**CALIFORNIA REGIONAL WATER QUALITY CONTROL BOARD
LAHONTAN REGION**

SUBJECT: **RESOLUTION AUTHORIZING THE EXECUTIVE OFFICER TO SIGN THE RECORD OF DECISION FOR OPERABLE UNIT 4, ARROYOS AREA, EDWARDS AIR FORCE BASE, KERN COUNTY**

STAFF REPORT

AIR FORCE RESEARCH LABORATORY – ARROYOS AREA

Figure 2. Arroyos Area Current Plume Extents & Major Sources Location Map

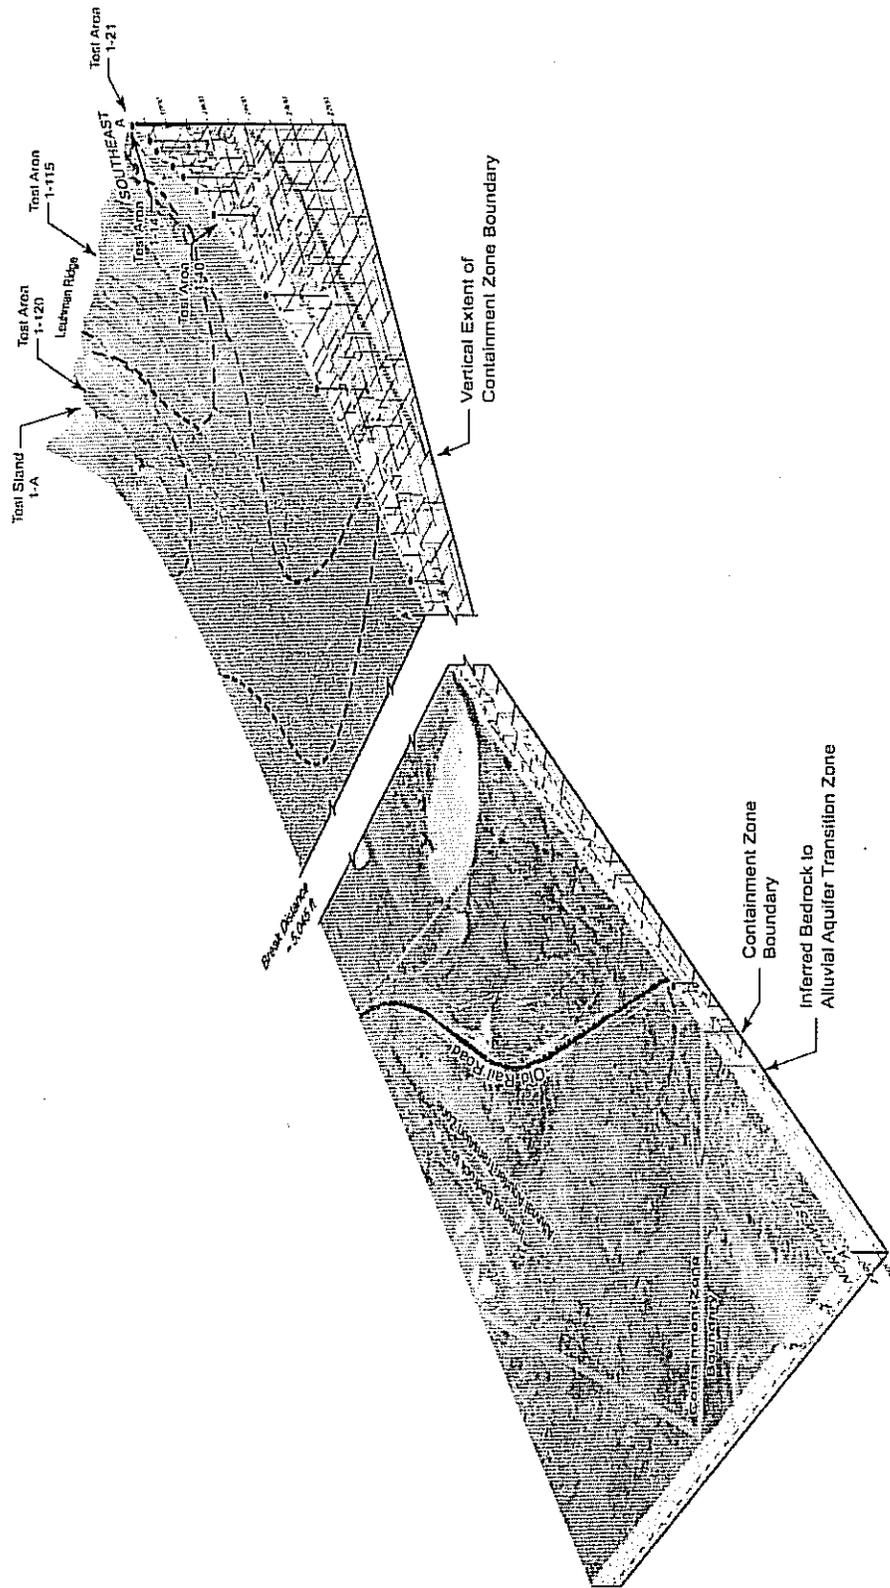
The groundwater plumes in the Arroyos Area emanate from two source areas: Site 162 (Test Areas 1-14, 1-21, 1-40) and Site 461 (Test Stands 1A and 1D, Test Areas 120, 125). Groundwater plumes from these two source areas have merged into solvent plume with an areal extent of 3,000 acres of which 1,720 acres exceed TCE's primary MCL of 5.0 micrograms

per liter ($\mu\text{g/L}$). The plumes have migrated about 7,000 feet from the source areas (see **Figure 2**). The estimated current volume of impacted water is 5,168 acre-feet.

To achieve the listed RAOs, the Air Force proposes a Containment Zone area of about 12.3 square miles covering the maximum predicted extent of the solvent contaminant migration (See **Figure 2**). The Air Force would not, due to technical impracticability from an engineering perspective, be required to attain the groundwater cleanup levels within the Containment Zone. The Air Force would ensure that groundwater cleanup levels (MCL values shown in **Table 2**) are attained at the Containment Zone boundary, through active measures if necessary. The proposed Containment Zone area does include a portion of the alluvial Antelope Valley aquifer (See **Figure 2a**).
